# SERVICE Counselor

PACKARD MOTOR CAR COMPANY

VOL. 26, NO. 3

MARCH, 1952

Fig. 2

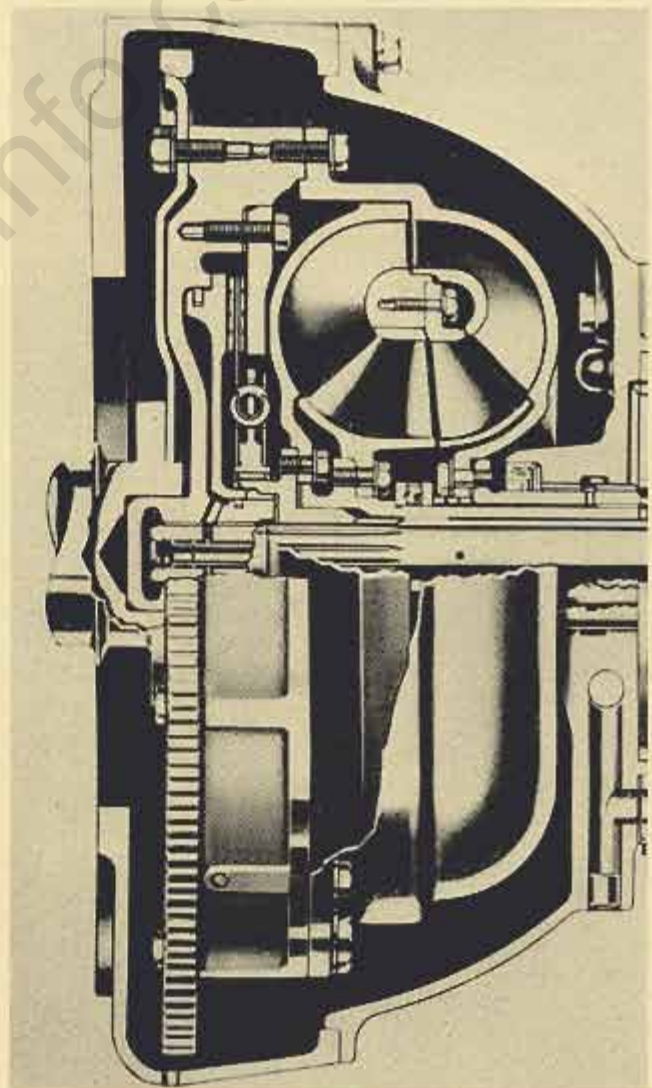
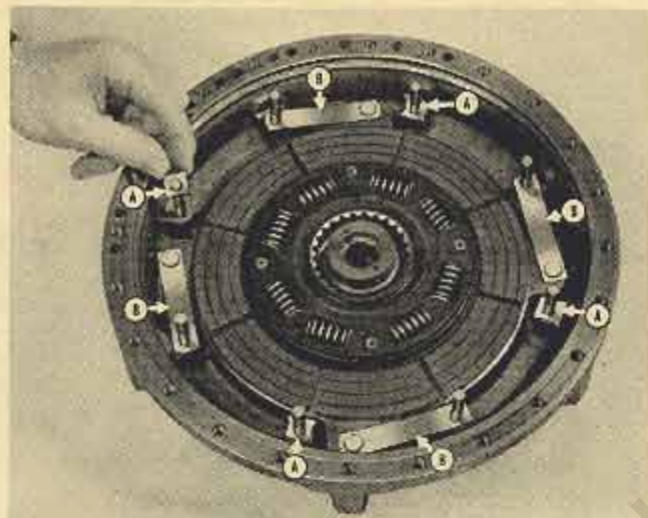
A new torque converter assembly has been designed and released for the 25th Series cars.

The newly designed torque converter assembly has the working surfaces improved by providing a smoother finish, resulting in smoother performance and increased torque output.

A most important change in the new converter assembly is the new direct drive clutch assembly, which gives smoother engagement, more positive release on coming to a stop, definite and quicker release on kick-down, and less drag, which improves converter performance.

Originally the direct drive clutch plate on the 23rd and 24th Series cars was 11 $\frac{3}{4}$ " in diameter, and this was later reduced to 11 $\frac{1}{4}$ ". The new torque converter assembly in the 25th Series cars incorporates a direct drive clutch plate 9" in diameter. The new 9" direct drive clutch plate is coned to provide smoother engagement and to reduce drag.

The direct drive clutch combination piston and driving plate is of new design, having four steel driving straps "B" Fig. 2, instead of lugs or splines as previously used. The reason for the change is that the lugs or splines caused the piston to drag or bind in the housing and consequently resulted in a sluggish release of the direct drive clutch.

25th Series production (approximately 3,074 cars); but these cars will be equipped with a service flywheel which will take either a 9" or 11 $\frac{1}{4}$ " converter assembly. The 9" converter assembly for the 25th Series cars is listed under Part Number 423430.
